SOLICITATION AMENDMENT
MODIFICATION DE L'INVITATION

Title - Sujet Designated Support Space	
Solicitation No. - N° de l'invitation ED001-172941/A	Amendment No. - N° modif. 003
Client Reference No. - N° de référence du client R.086261.003	Date 2017-02-23
GETS Reference No. - N° de référence de SEAG PW-\$PWC-008-4093	
File No. - N° de dossier PWC-6-39194 (008)	CCC No./N° CCC - FMS No./N° VME
Solicitation Closes - L'invitation prend fin at - à 02:00 PM on - le 2017-03-01	
F.O.B. - F.A.B. Plant-Usine: <input type="checkbox"/> Destination: <input checked="" type="checkbox"/> Other-Autre: <input type="checkbox"/>	
Address Enquiries to: - Adresser toutes questions à: Reay, D (PWC)	Buyer Id - Id de l'acheteur pwc008
Telephone No. - N° de téléphone (902) 566-7518 ()	FAX No. - N° de FAX (902) 566-7514
Destination - of Goods, Services, and Construction: Destination - des biens, services et construction:

The following changes in the tender documents are effective immediately. This addendum will form part of the contract documents.

This Addendum is raised to provide the following answers to questions provided by bidders (Site Visit, February 21, 2017).

PWSCC Project Manager / Administrateur de projets TPSCC
 Project number / no. du projet: **R.086261.003**
 drawing no. / no. du dessin: **ASK#001**

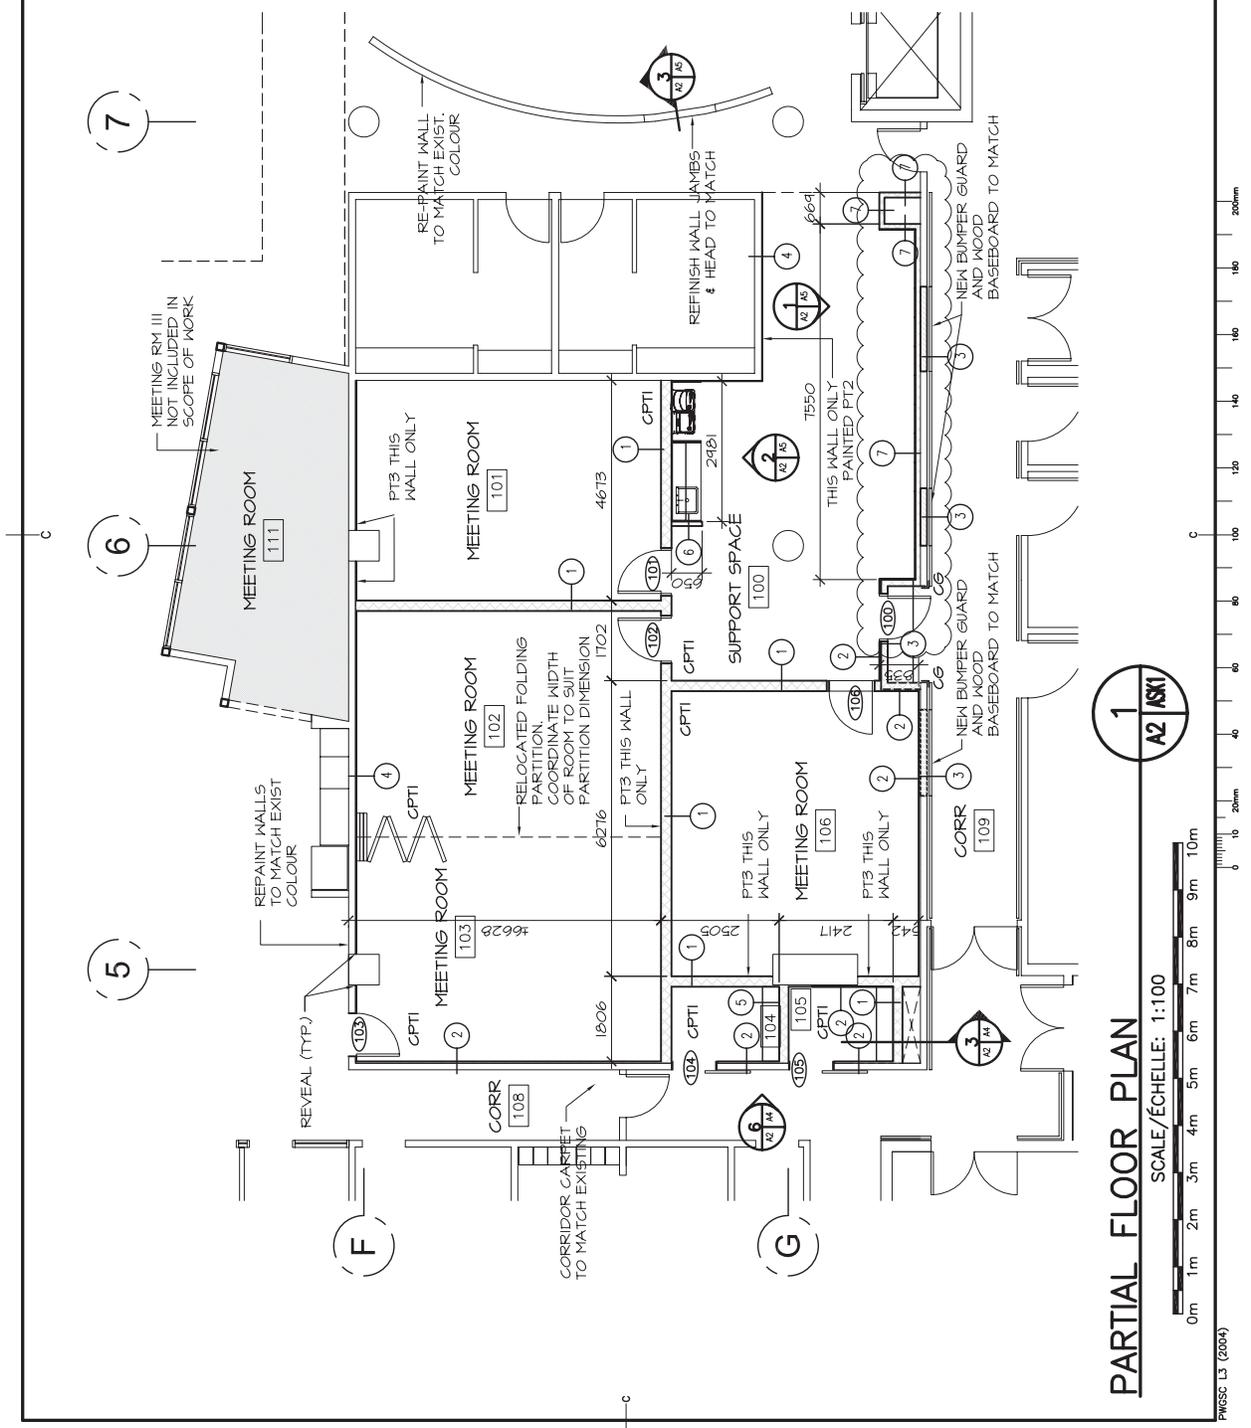
- .1 Ref. Drawing A2 – Detail 1/A2/A2
 - .1 Replace detail entirely with appended sketch 1/A2/ASK#001.
 - .2 Delete requirement for door 100A and associated closet.

- .3 Extend wood surround into former Closet space
 - .4 Revise location of page right wall of alcove associated with Door 100 to the right as required to facilitate 610mm equal wood panel dimensions.

- .5 Furr out page south wall behind wood paneling with a continuous type W7 wall to accommodate new electrical services. Decrease depth of panel assembly to suit.

- .6 Allow for cutting and repair of existing suspended concrete slabs to accommodate installation of new recessed floor boxes indicated within the body of this addendum below.

PWSSC Project Manager
Administrateur de projets TPSSC
project number
R.086261.003
no. du projet
drawing no.
ASK#002

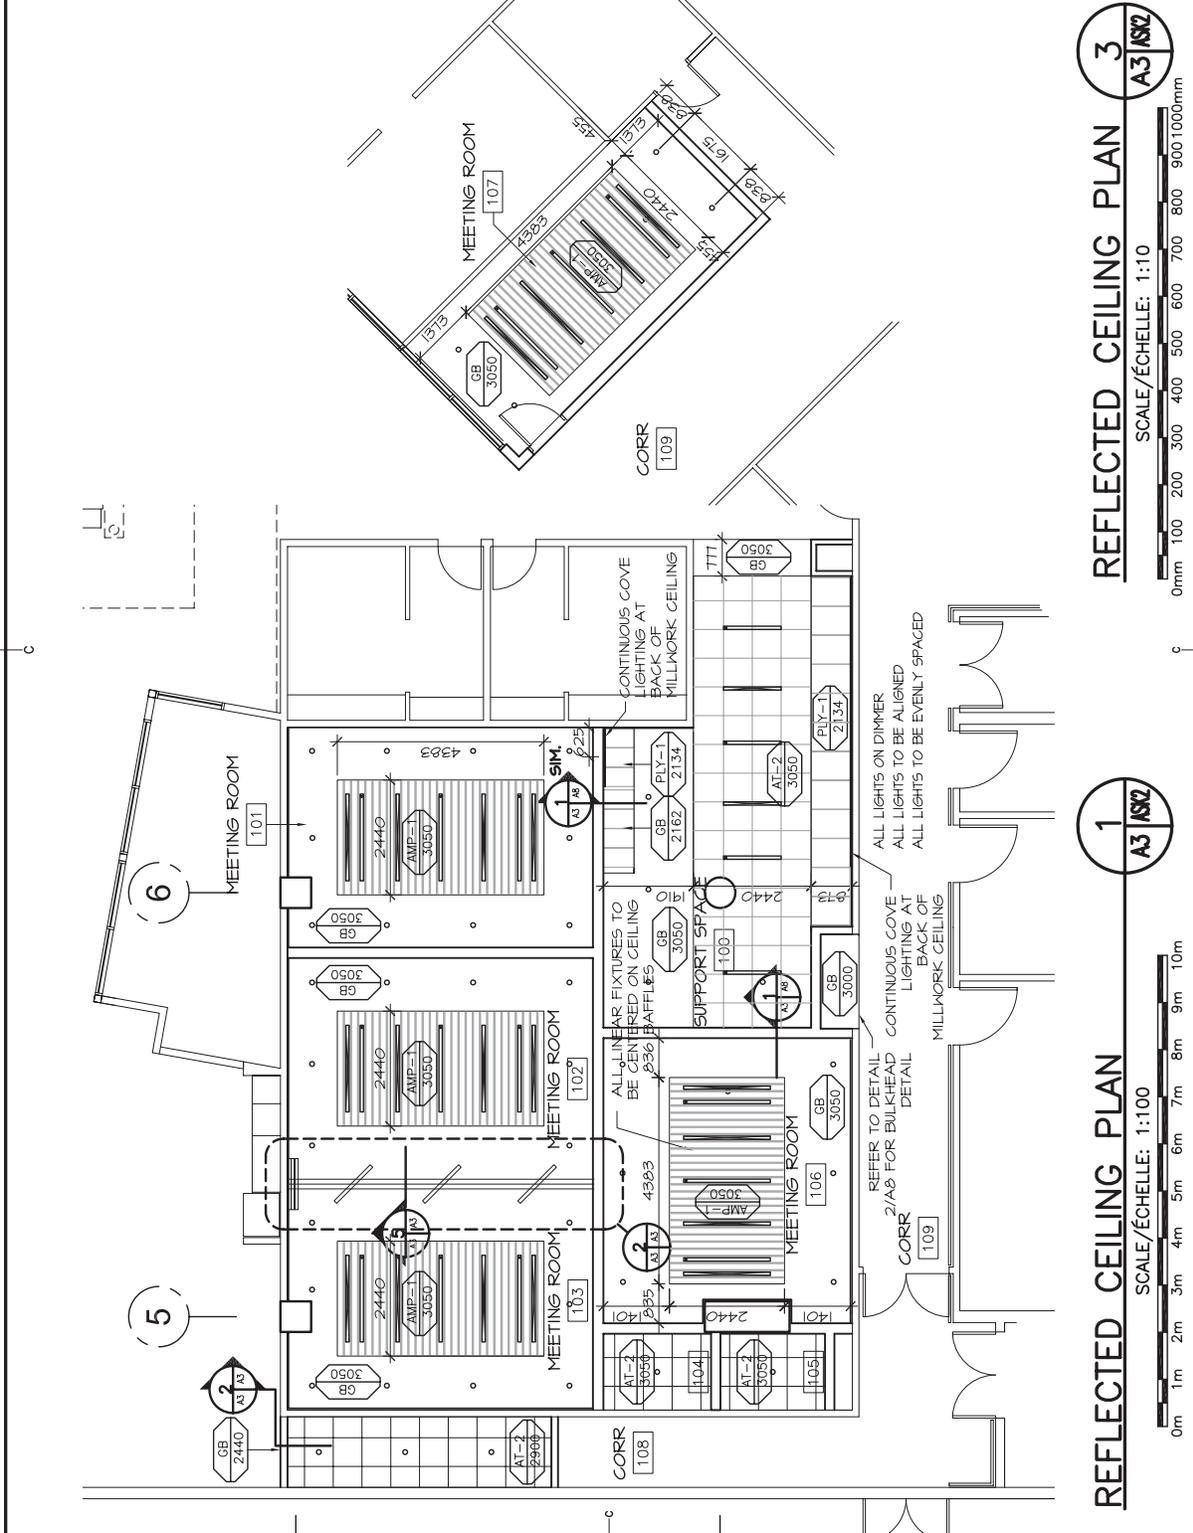
- .2 Ref. Drawing A3 – Detail 1
 - .1 Replace detail entirely with appended sketch 1/A3/ASK#002. Note revisions to ceiling dimensions, and types throughout.

- .3 Ref. Drawing A3 – Detail 3
 - .1 Replace detail entirely with appended sketch 3/A3/ASK#002. Note revisions to ceiling dimensions, and types throughout.

5
A3 ASK

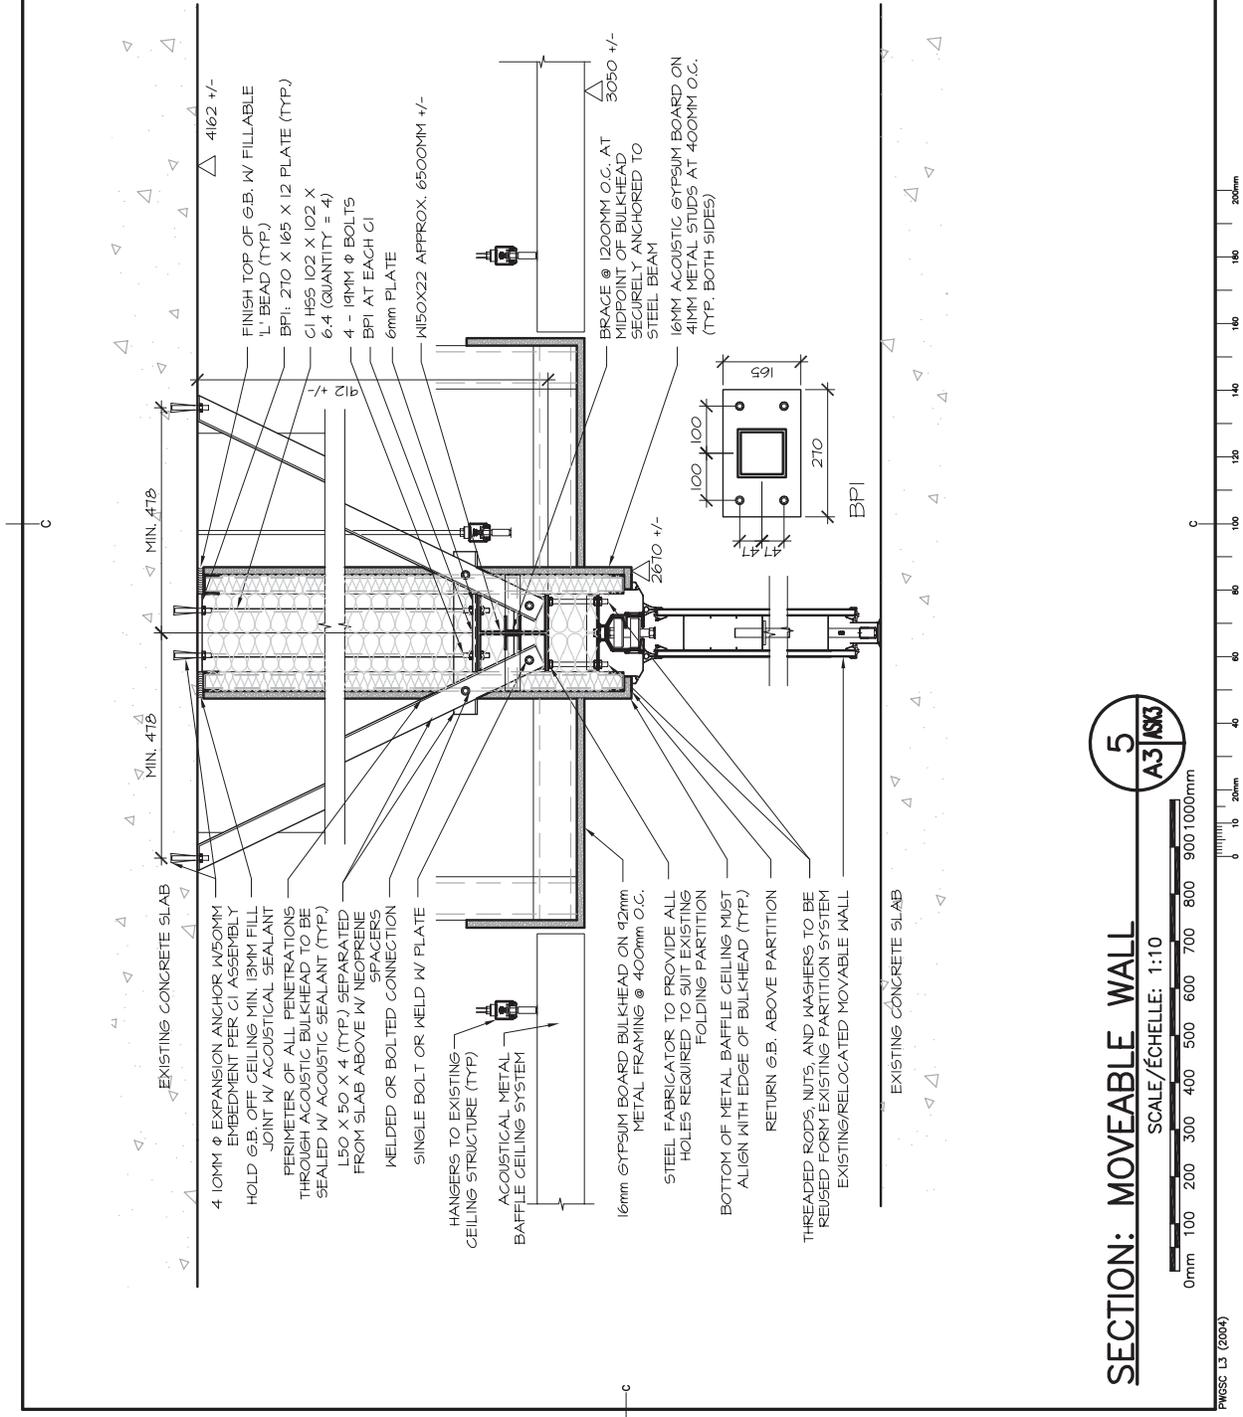
- .4 Ref. Drawing A3 – Detail 5
 - .1 Replace detail entirely with appended sketch 5/A3/ASK#003
- .5 Ref. Drawing A4 – Detail 1
 - .1 Delete door type D3
 - .2 Dimensions of style and rail of door D4 to be 200mm each.

1
A2/ASK

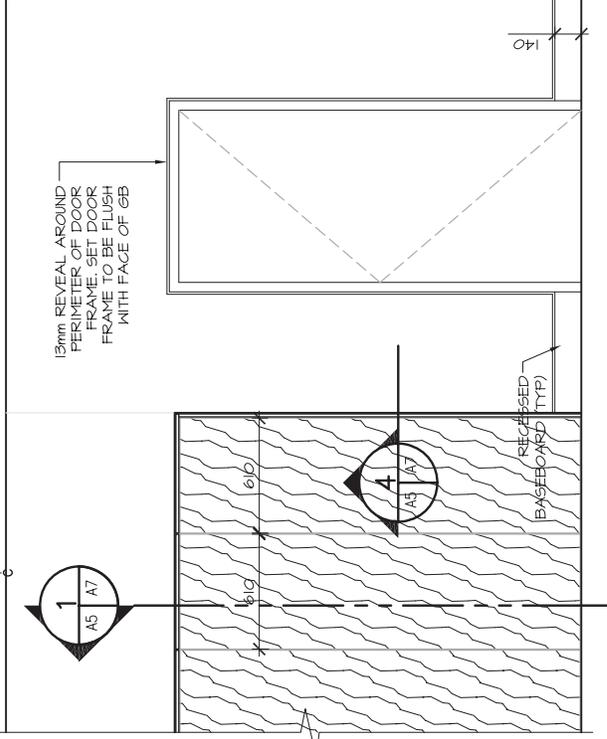
- .8 Ref. Drawing A5 – Detail 1
.1 Replace detail entirely with appended sketch 1/A2/ASK#004
- .9 Ref. Detail A7 – Detail 1
.1 Replace detail entirely with appended sketch 1/A5/ASK#005

4
A5/ASK

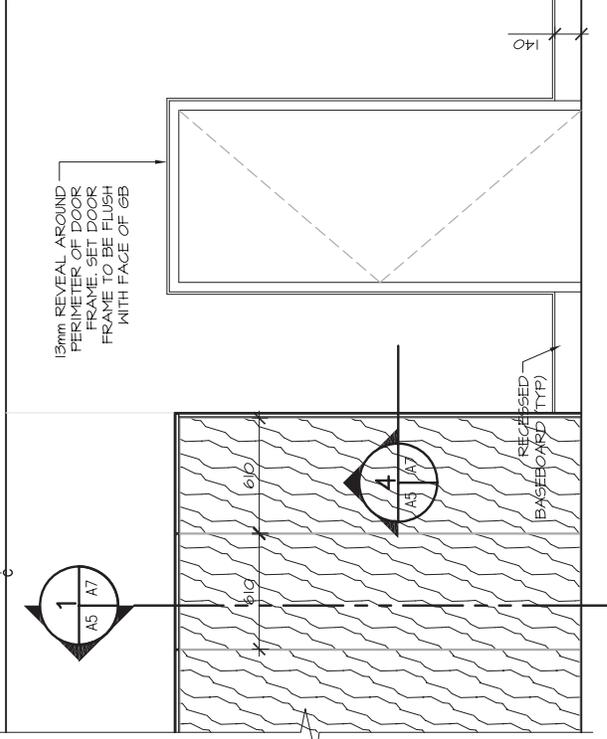
- .10 Ref. Detail A7 – Detail 4
.1 Replace detail entirely with appended sketch 4/A5/ASK#004
- .11 Ref. Detail A8 – Detail 1
.1 Revise detail as follows:
.1 Baffles to be installed at 152mm o.c.
.2 Dimension from drywall bulkhead to centerline of first baffle to be such as
to create a void similar to that between two baffles.
